LAKESHORE PARK BUILDING JSP17-43

Consideration at the request of NSA Architects, Engineering, Planners for approval of Preliminary Site Plan and Stormwater Management Plan. The subject property is located in Section 3 west of Old Novi Road and south of South Lake Drive and is zoned R-4, One Family Residential. The applicant is proposing an update to Lakeshore Park in the City of Novi including an approximately 9,400 square foot community center, 129 parking spaces, one pavilion, and a bike lane to connect to the mountain biking trails.

MOTION SHEET

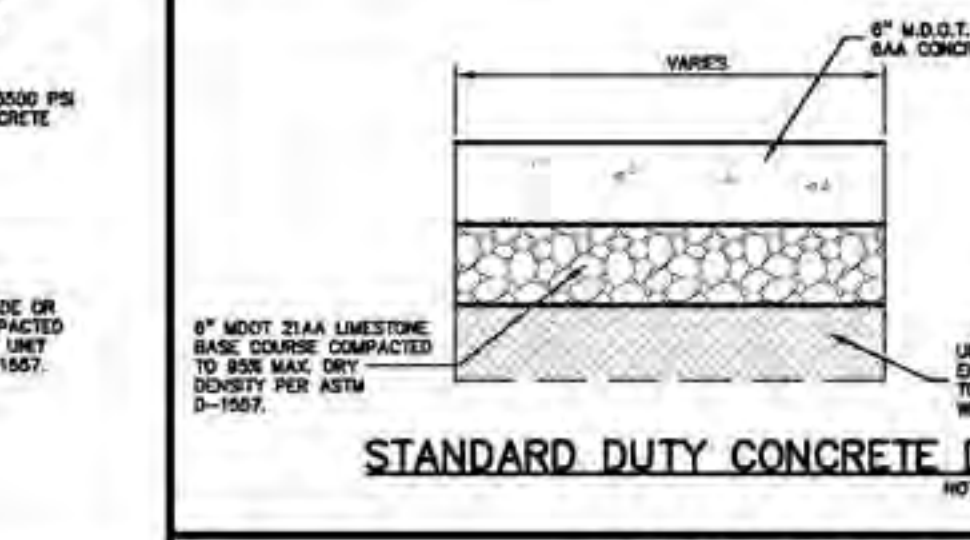
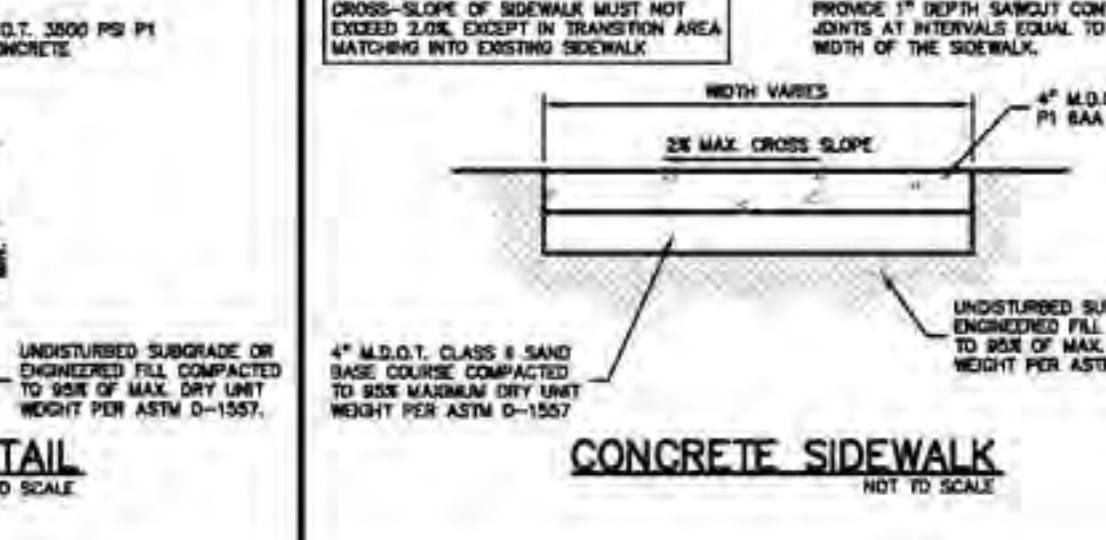
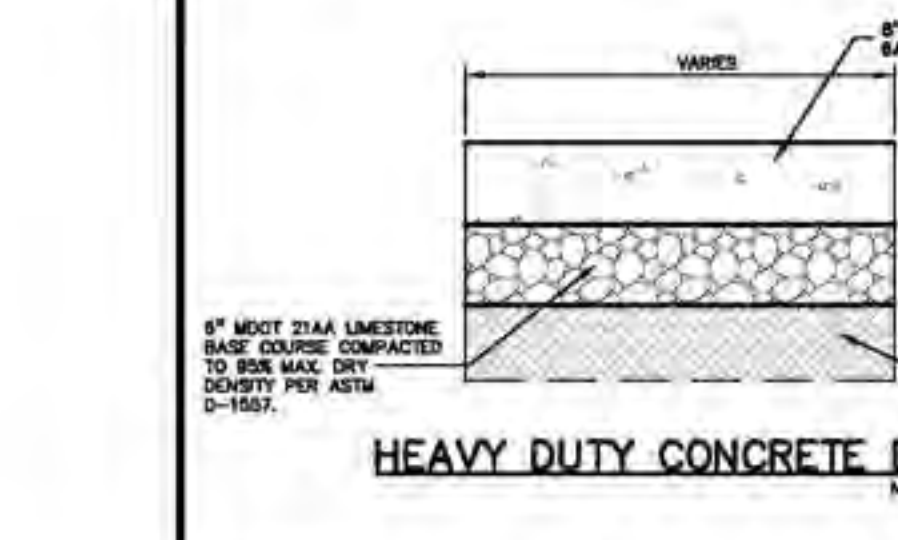
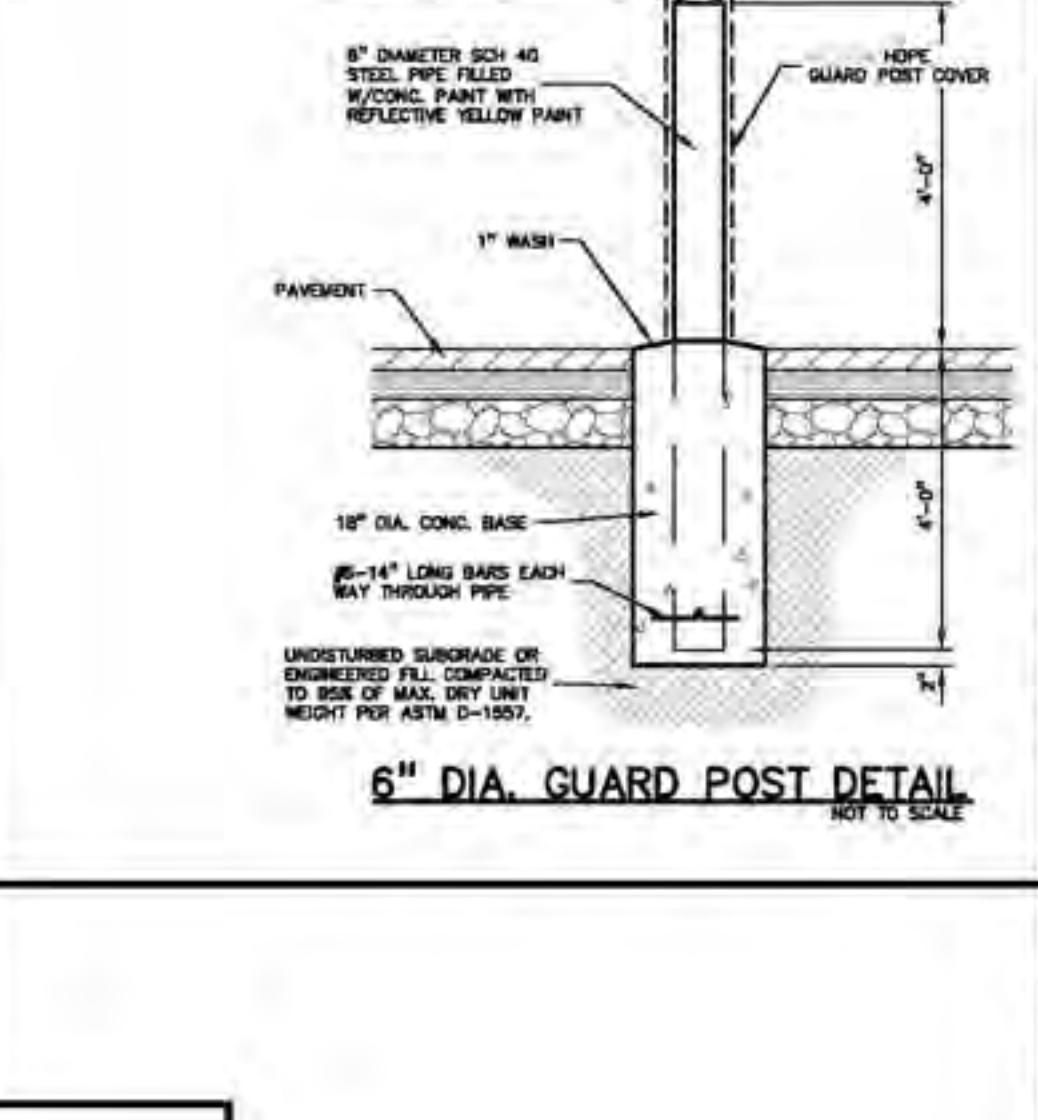
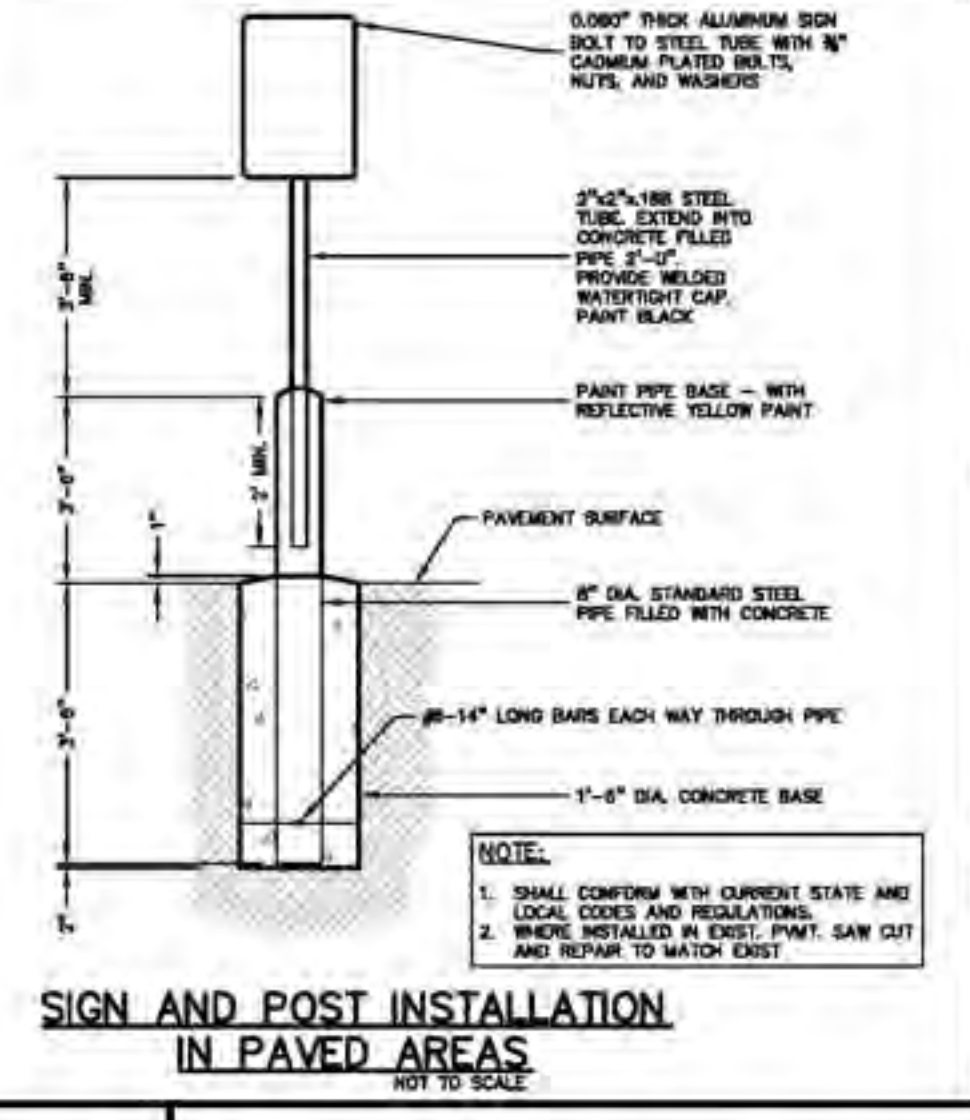
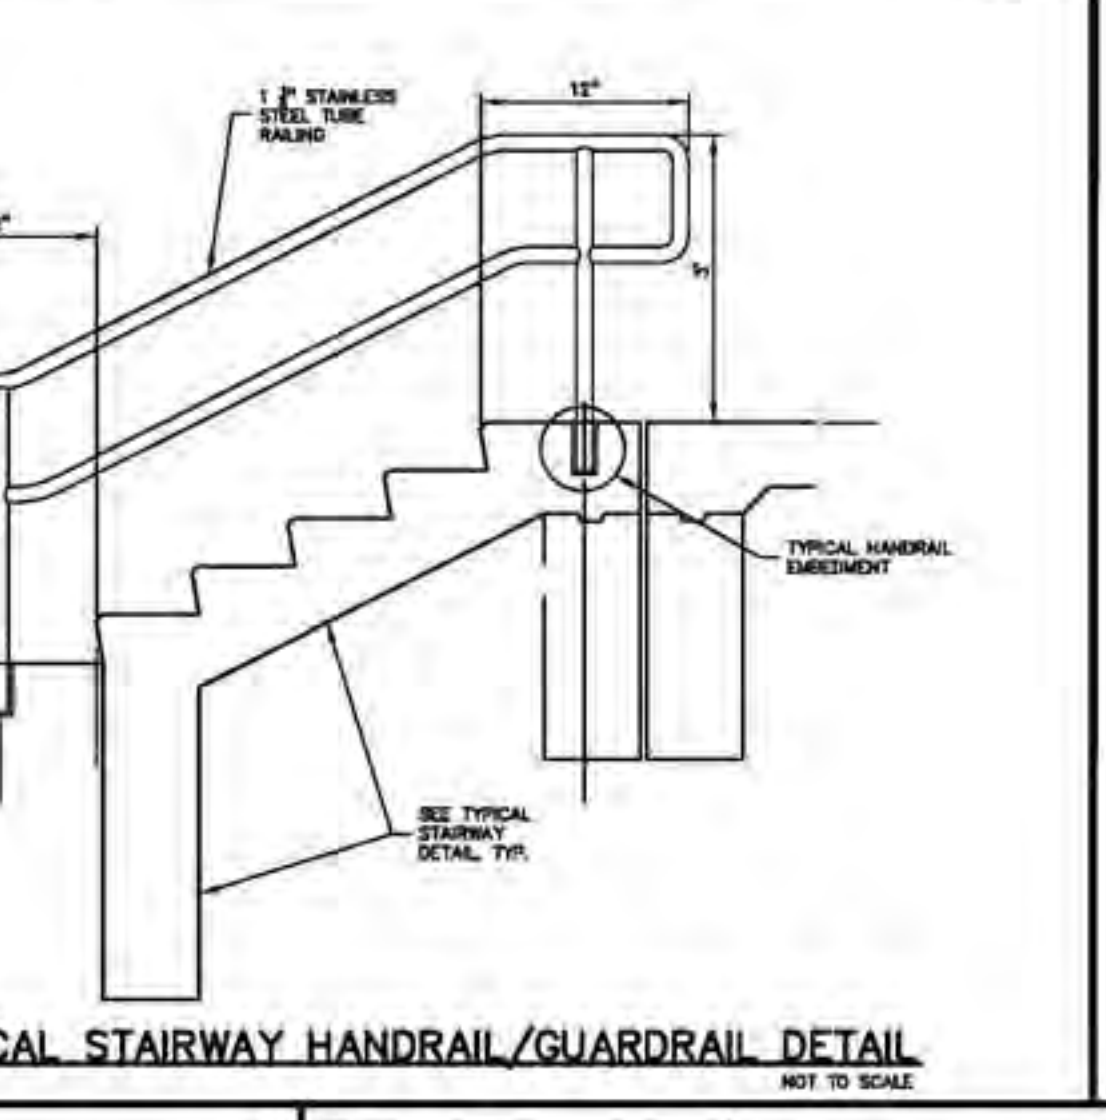
8. Replace the sidewalk detail shown on sheet C10.1 with the City's standard sidewalk cross section.

Response: Detail will be updated on sheet C-10.1 to reflect a 4" block.

Response: Sign details on C-10.1 will be updated to reflect the correct u-channel.

ORIGINAL ISSUE DATE: JUNE 30, 2017
PEA JOB NO. 2016-308
SCALE: 1" = 40'
DRAWING NUMBER: L-1.0

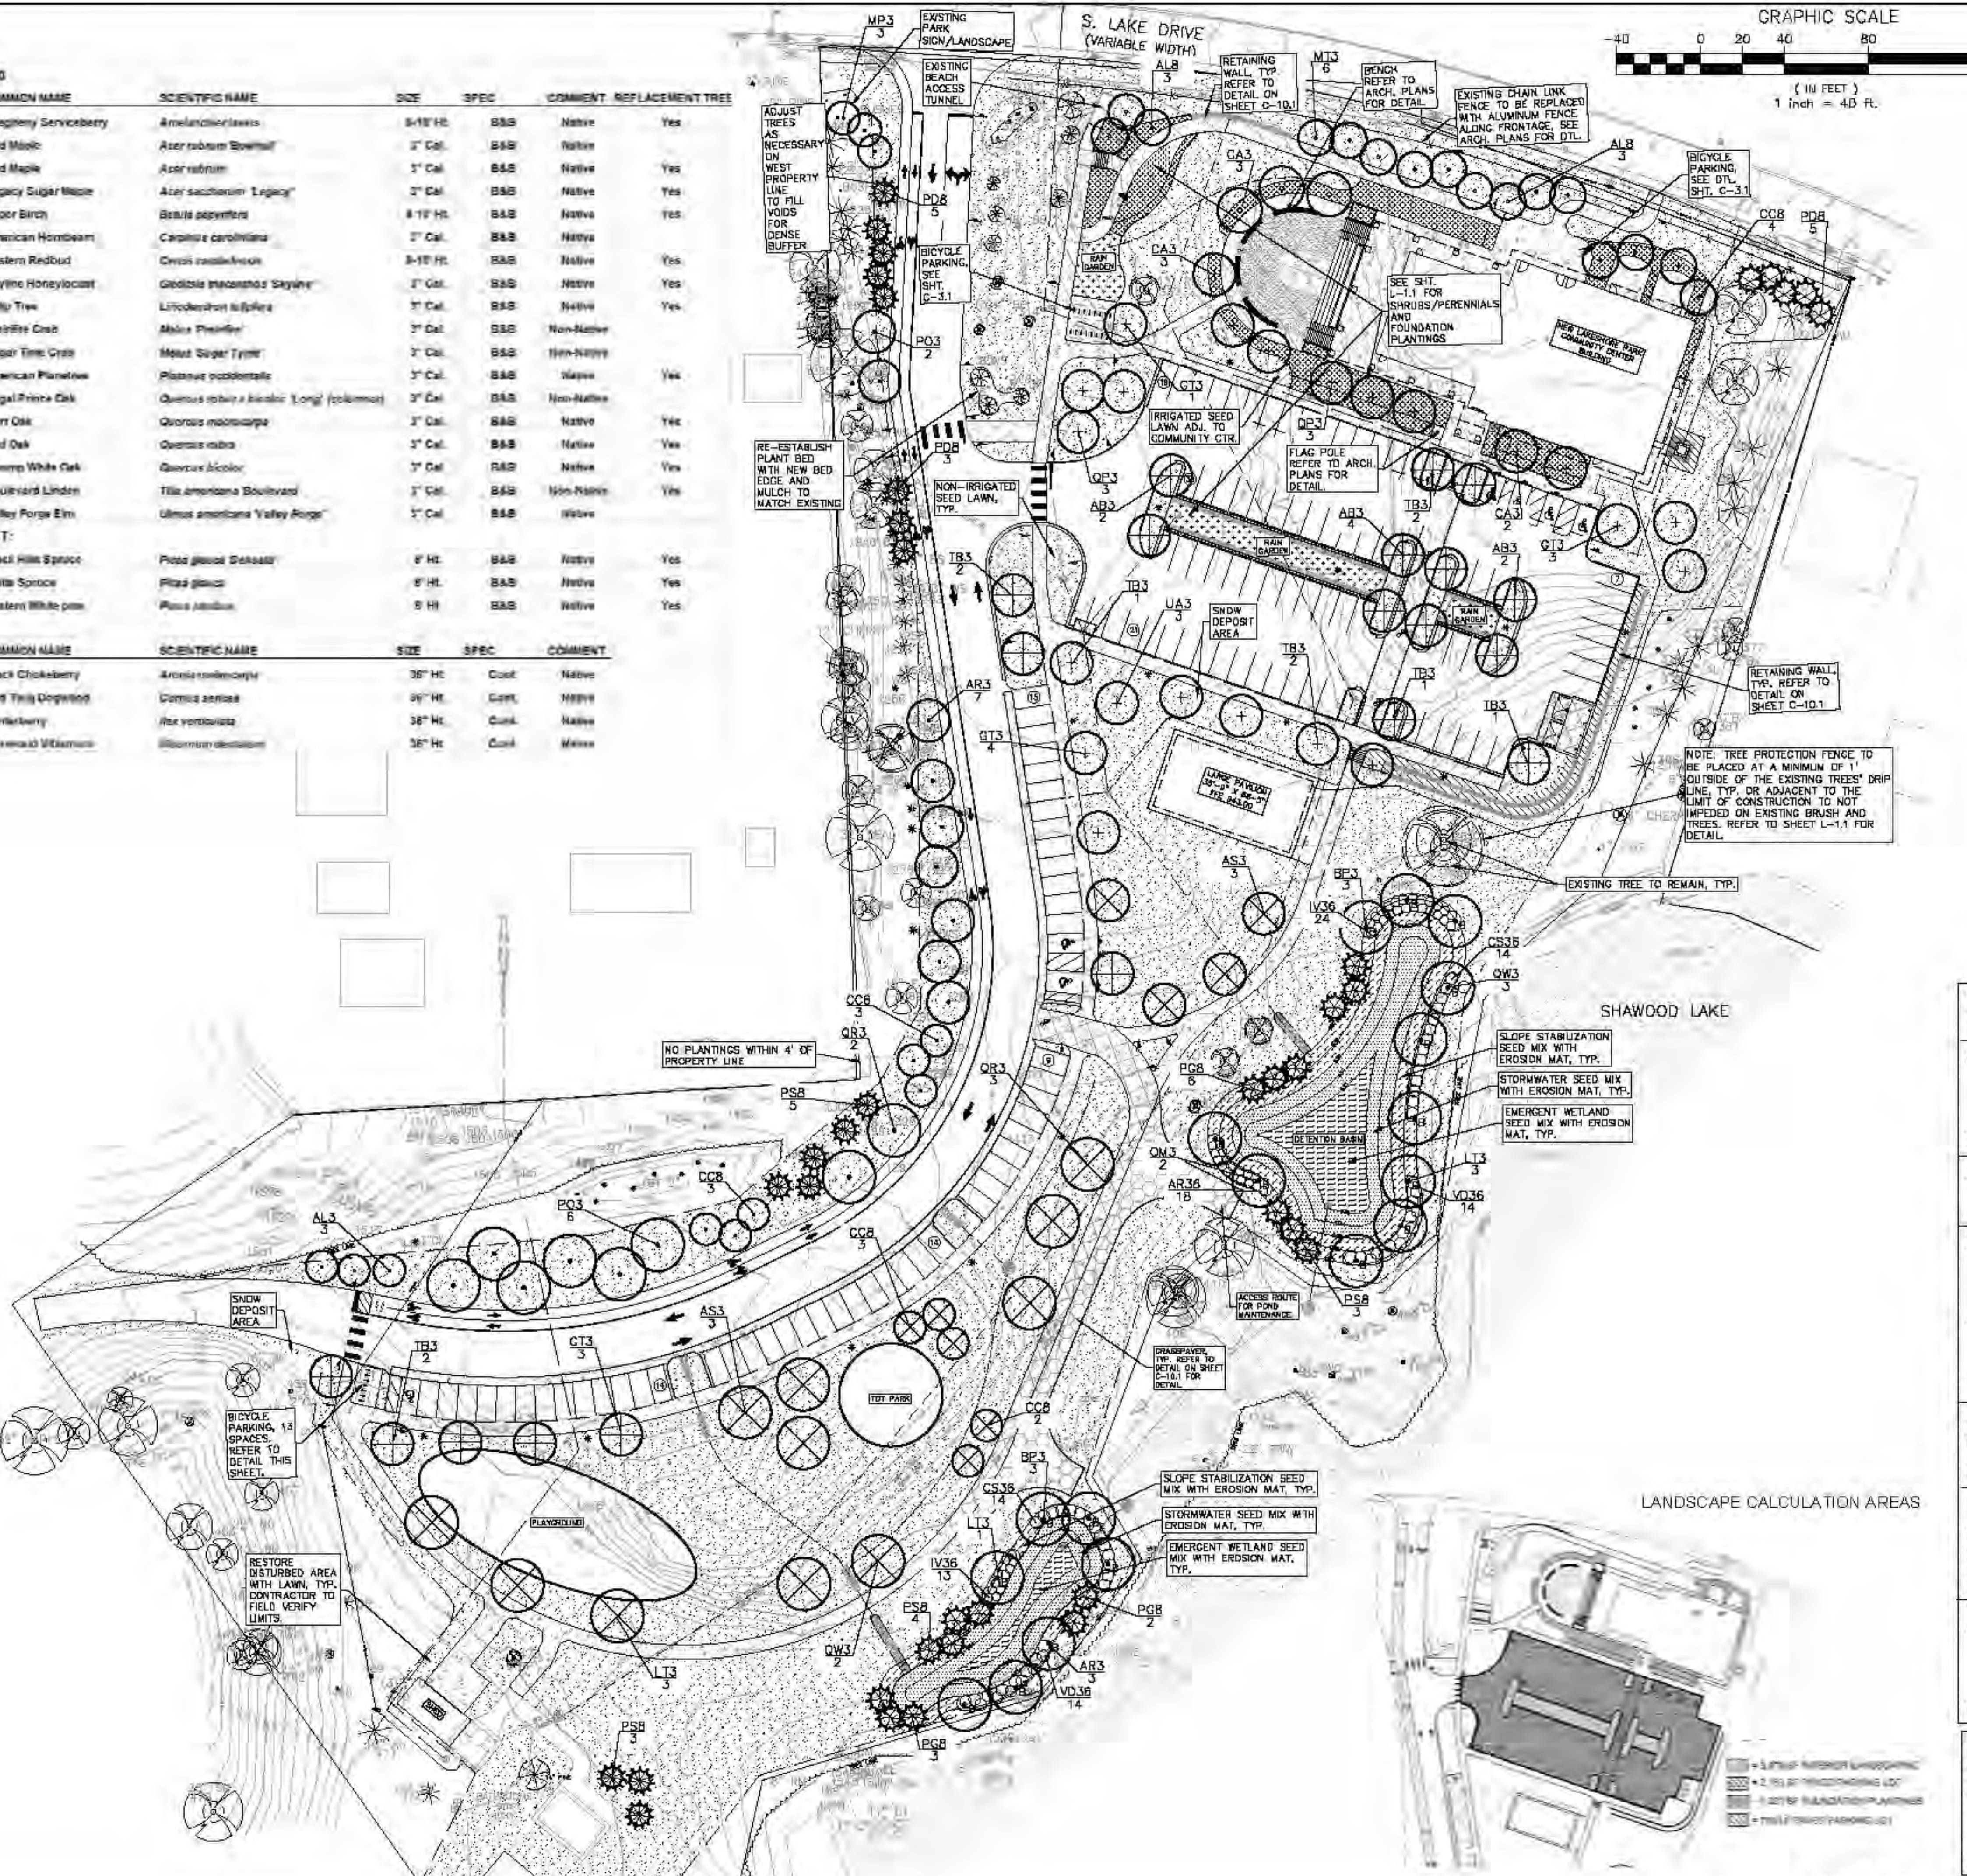
Response: Waiver requested due to insufficient room between ROW and road. Waiver request will be added to Sheet L-1.0.

Response: Plan will be adjusted to provide only native shrubs at the detention area, no trees, no waiver requested. Changes will be shown on sheet L1.0.

Response: Per the agreement with the city, existing diseased trees will be removed and infilled with new plantings; no wall to be provided. Changes will be shown on sheet L-1.0.

Response: Island drainage configurations will be adjusted so a required tree can be planted in the island. Changes will be shown on sheet L-1.0.
